SERVICE BULLETIN #1098

MODEL **MISCELLANEOUS** DATE 7/1/60

SUBJECT **INSTALLATION OF UNIVERSAL AIRBOX ASSEMBLY**

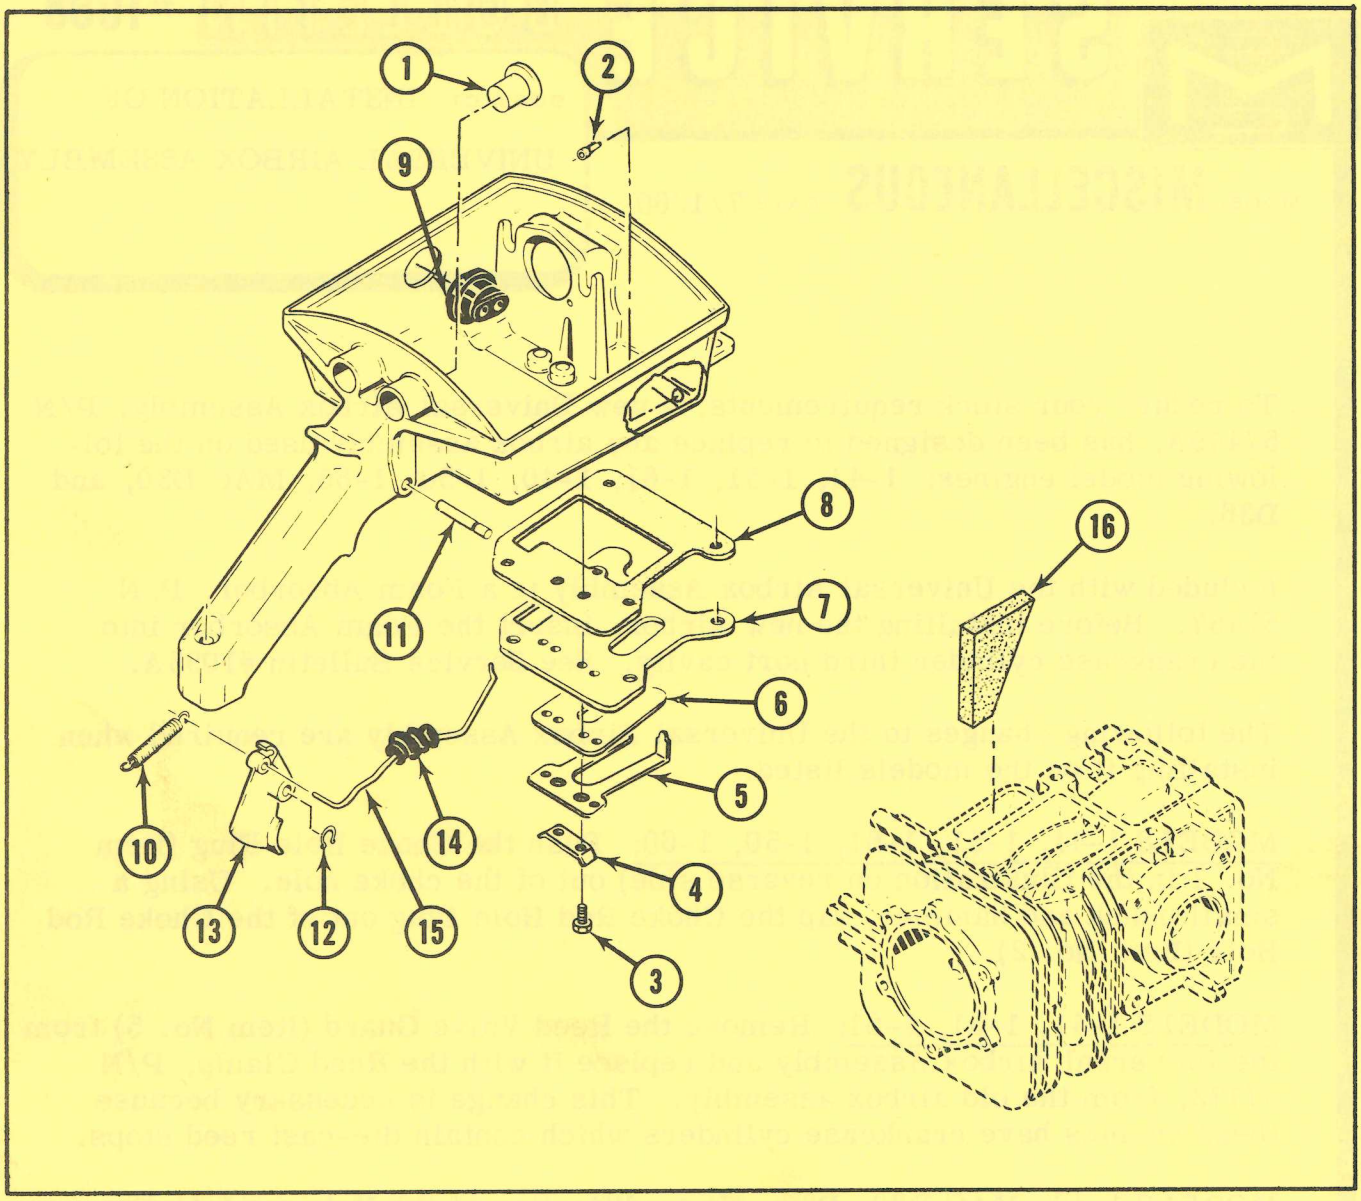
To reduce your stock requirements, a new Universal Airbox Assembly, P/N 57449A, has been designed to replace any airbox assembly used on the following model engines: 1-41, 1-51, 1-61, 1-40, 1-50, 1-60, MAC D30, and D36.

Included with the Universal Airbox Assembly is a Foam Absorber, P/N 57457. Before installing the new Airbox, insert the Foam Absorber into the crankcase cylinder third port cavity. See Service Bulletin #1093A.

MODELS 1-41, 1-51, 1-61, 1-50, 1-60: Push the Choke Hole Plug (Item No. 1 in the illustration on reverse side) out of the choke hole. Using a small punch and hammer, tap the Choke Rod Hole Plug out of the Choke Rod Hole (Item No. 2).

MODELS 1-41, 1-51, 1-61: Remove the Reed Valve Guard (Item No. 5) from the Universal Airbox Assembly and replace it with the Reed Clamp, P/N 57173, from the old airbox assembly. This change is necessary because these engines have crankcase cylinders which contain die-cast reed stops.

MODELS 1-40, MAC D30, D36: No modification of the Universal Airbox Assembly is required.
